**State of Alaska  
Department of Fish and Game  
Sportfish Division**

**Nomination Form  
Anadromous Waters Catalog**

Name of Water Body Big Sandy Creek  USGS Name  Local Name

Nomination # <u>25-593</u>	<u>[Signature]</u> Fisheries Scientist	<u>Sept 05/2025</u> Date
Revision Year: <u>2026</u>	<u>[Signature]</u> Habitat Operations Manager	<u>9/5/25</u> Date
Revision to: <input checked="" type="checkbox"/> Atlas <input checked="" type="checkbox"/> Catalog	<u>[Signature]</u> AWC Project Biologist	<u>4 Sept 2025</u> Date
Revision Code: <u>C-9, D-2</u>	<u>P. [Signature]</u> GIS Analyst	<u>10/6/2025</u> Date

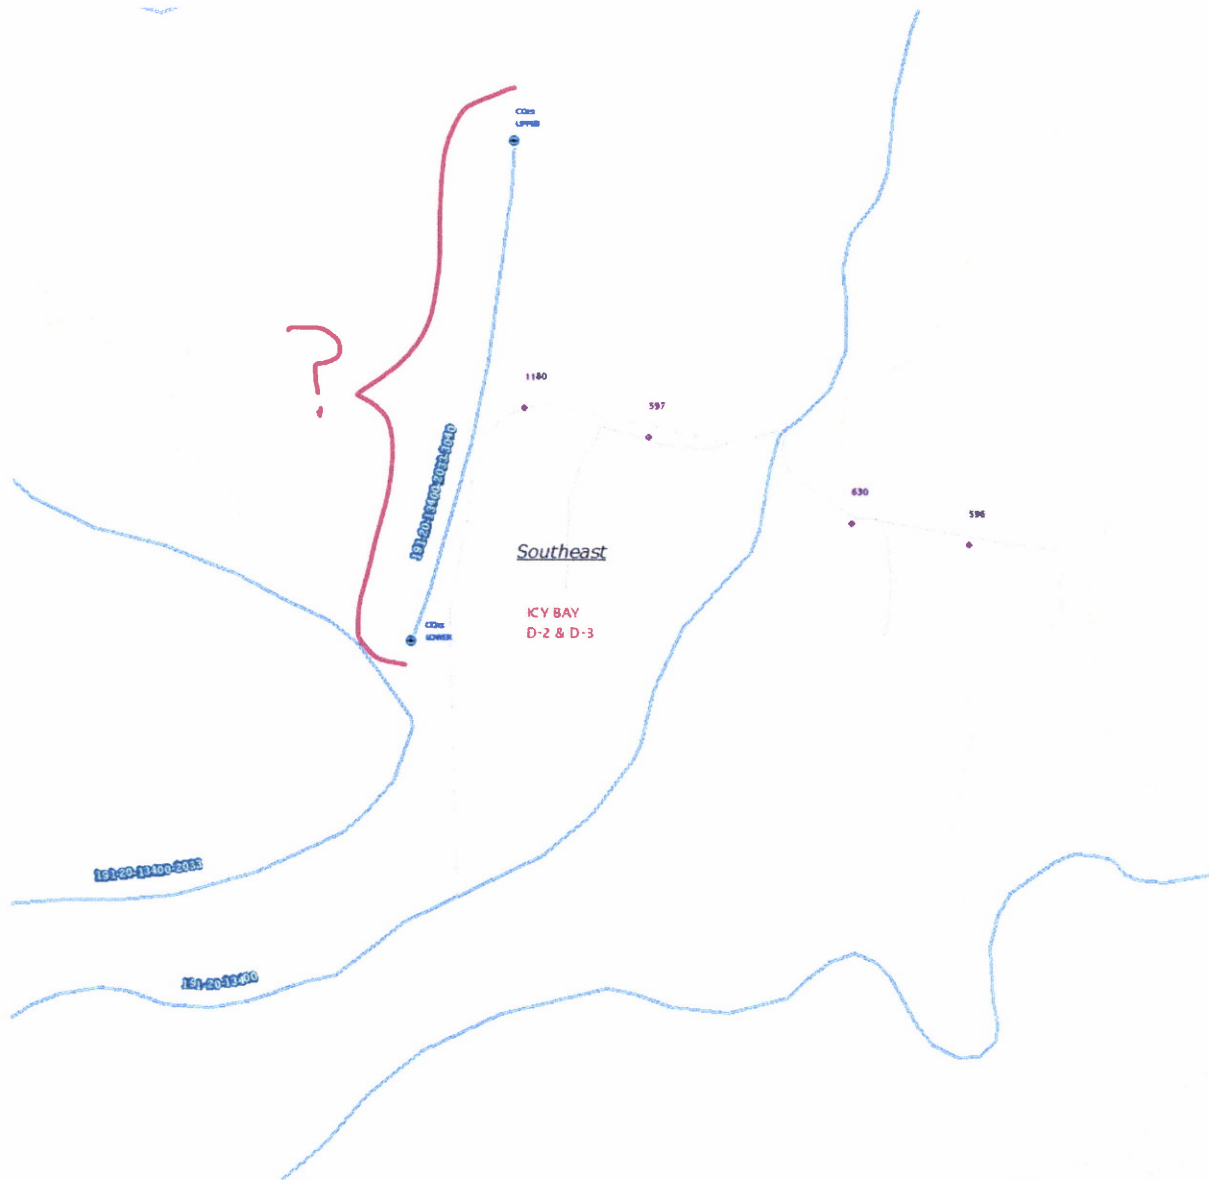
It looks to me like the correction flows awfully close to where stream #191-20-13400-2033-3040 is depicted. However, looking at the nom record of that stream (Nom #92-752, attached) the original observation mentions this was meant to be a "tributary of Big Sandy Creek". To me this implies this was likely mapped incorrectly in the original submission and made a tributary of -2033.

Any suggestions? Remove stream #191-20-13400-2033-3040 and tie it's nom history to Big Sandy Creek? Create a short tributary and renumber 191-20-13400-2033-3040 so it's an actual tributary of Big Sandy flowing in at approximately waypoint #1180?

In this scenario, I'd recommend getting rid of stream 191-20-13400-2033-3040 and tie its info with Big Sandy. We didn't see any evidence of it along the road, although I'm not surprised with how dynamic this watershed is. Maybe at the time they submitted it, it looked like a trib, but in actuality it was a braid...I'm not exactly sure.
